Manual Supplement

Manual Title:	744 Users	Supplement Issue:	6
Part Number:	691287	Issue Date:	4/06
Print Date:	September 1998	Page Count:	8
Revision/Date:	1, 2/99

This supplement contains information necessary to ensure the accuracy of the above manual.

Figure A. Sourcing Temperature using Drywell

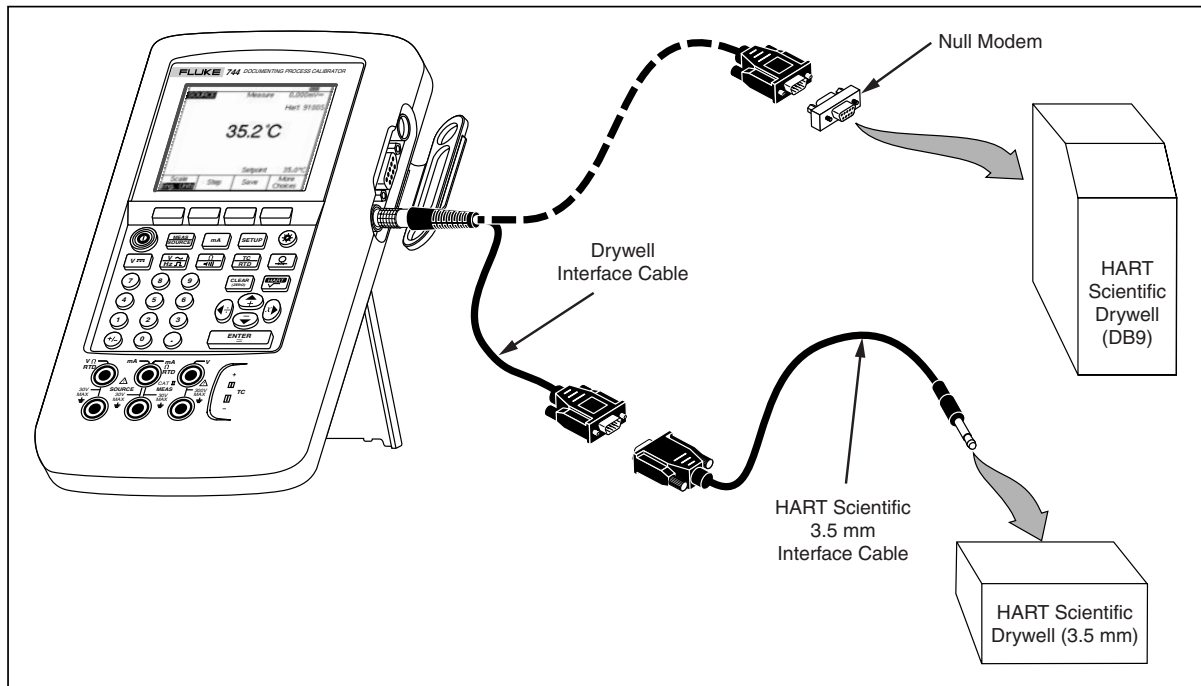
On page 59, before **Source Scale**, add the following:

Sourcing Temperature using a Hart Scientific Drywell

Connect the 744 to the drywell by plugging the drywell interface cable into the pressure module connector as shown in Figure A. If the drywell has a DB9 connector, plug the drywell interface cable directly into the drywell using the DB9 Null Modem adapter. Drywells with the 3.5 mm jack connector need to use the serial cable supplied with the drywell in addition to the 744 drywell interface cable. Join the DB9 connectors of the two cables, and connect the 3.5 mm jack to the drywell.
